DEVELOPMENT REVIEW BOARD REPORT

Aire on McDowell 26-DR-2016

Request: Approval of the building elevations, perimeter theme wall design, and entry feature for a new residential subdivision, with 80 lots on an approximately 6.8-acre site.

Exterior Elevations Building D With Optional Bulkheads Shown

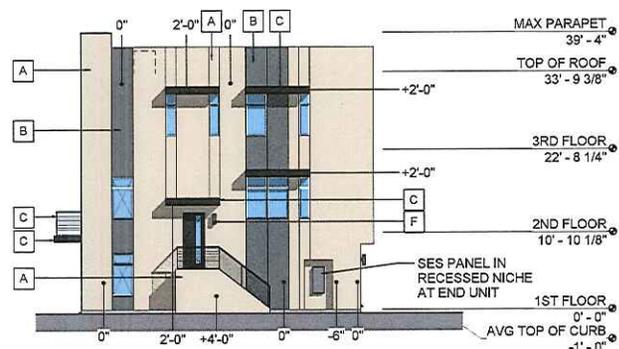
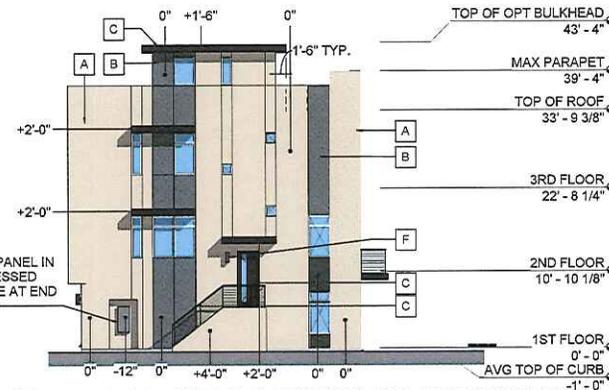
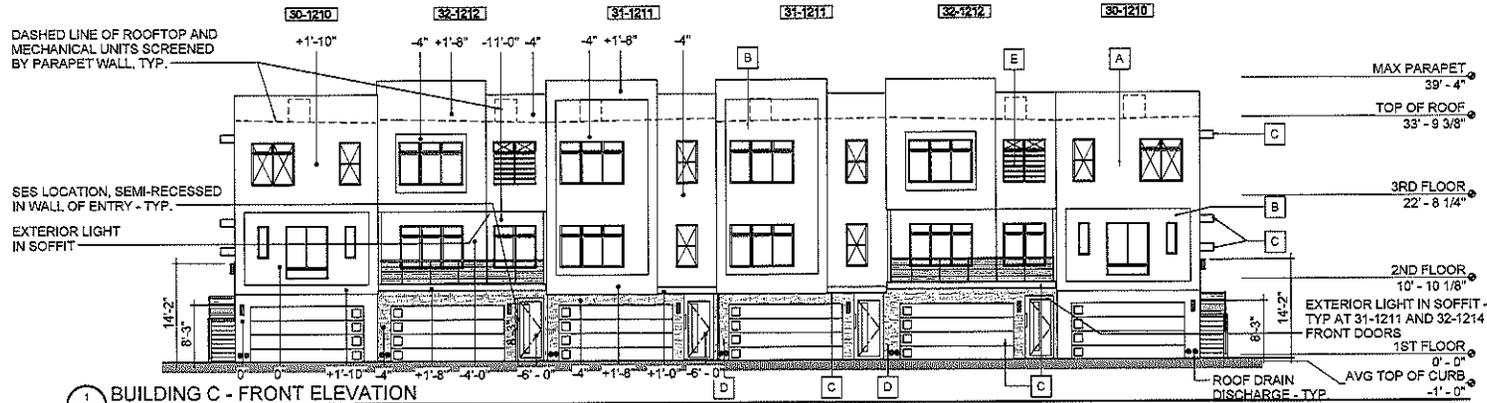
3. All exterior window glazing shall be recessed a minimum of fifty (50) percent of the wall depth, including glass windows within any tower/clerestory elements. The amount or recess shall be measured from the face of the exterior wall to the face of the glazing, exclusive of external detailing. With the final plan submittal the developer shall provide head, jamb and sill details clearly showing the amount of recess for all window types.

- GLAZING THAT MEETS RECESS CRITERIA 764 OF 971 SF = 79%
- GLAZING BELOW RECESS CRITERIA 207 OF 971 SF = 21%

- GLAZING THAT MEETS RECESS CRITERIA 88 OF 124 SF = 71%
- GLAZING BELOW RECESS CRITERIA 36 OF 124 SF = 29%

- GLAZING THAT MEETS RECESS CRITERIA 89 OF 131 SF = 68%
- GLAZING BELOW RECESS CRITERIA 42 OF 131 SF = 32%

- GLAZING THAT MEETS RECESS CRITERIA 1,184 OF 1,184 SF = 100%
- GLAZING BELOW RECESS CRITERIA 0 OF 1,184 SF = 0%

McDOWELL ROAD WALL COMPOSITE

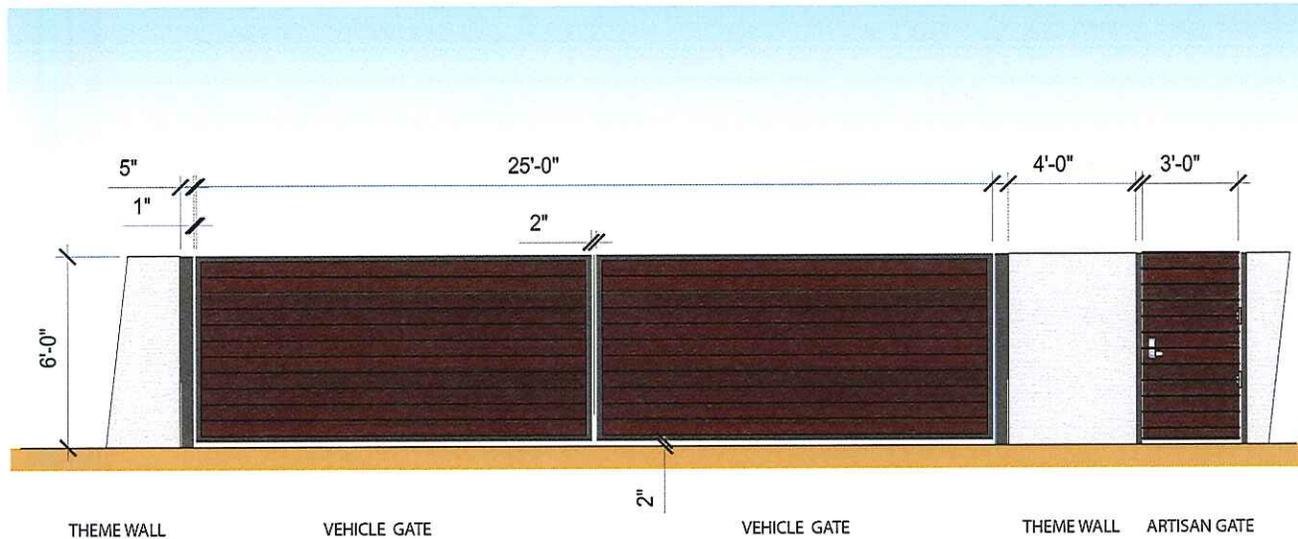
pedestrian experience. Per the zoning stipulation, final design of the Art Wall Element is subject to DRB approval. At the 4/21 DRB hearing, the Board was generally supportive of the wall design; however, questioned the use of “wave” elements in the wall design that appeared to mirror the design utilized at the Las Aguas project west of this site. The Board felt this element of the design should be eliminated. Additionally, the Board had questions about how some of the materials, particularly the diagonal glass “rain” features would be attached to the wall and, taking into consideration the intricacies of the design, how the wall would be maintained. Since that hearing, the applicant has revised the design of the wall to introduce slate panels and vertical trellises capable of supporting vines or other plantings as the primary “artistic” elements of the wall. Staff questions if this new, contemporary design meets the intent of the zoning stipulation, given the more dramatic and unique theme of the original design. Staff recommends the original design be utilized, without the “wave” element. Also part of this application is the pedestrian gates for the lots fronting McDowell Road, as well as the main entry gate for the subdivision. These gates utilize dark walnut wood slats to create a dramatic and sturdy appearance in keeping with the linear theme of the building design.

2. *Art Theme Wall design shall be consistent with the design provided as part of the zoning case (15-ZN-2015) and included as Attachment #6 to this report, without the "wave" element.*

The wall design features a sophisticated smooth stucco, light beige colored finish with a contrasting slate tile column pattern flanking the pedestrian gates. Pedestrian gates accessing each unit's yard project from the linear plane of the wall. The gates are made up of horizontal Ipe plank slats stained a stylish dark walnut and abut each other without picket openings. The pedestrian gate projection will also be accented with colorful bougainvillea on each side. The conjunction of the calculated simple lines and cool colors of the stucco wall and slate tiles juxtaposed against the warm organic wood gates and colorful Bougainvillea create an interesting and aesthetic impression complementary to the modern elegant theme of the homes within the wall. The vehicular gates have been designed to correspond with the pedestrian gates and will utilize the same Ipe planks.
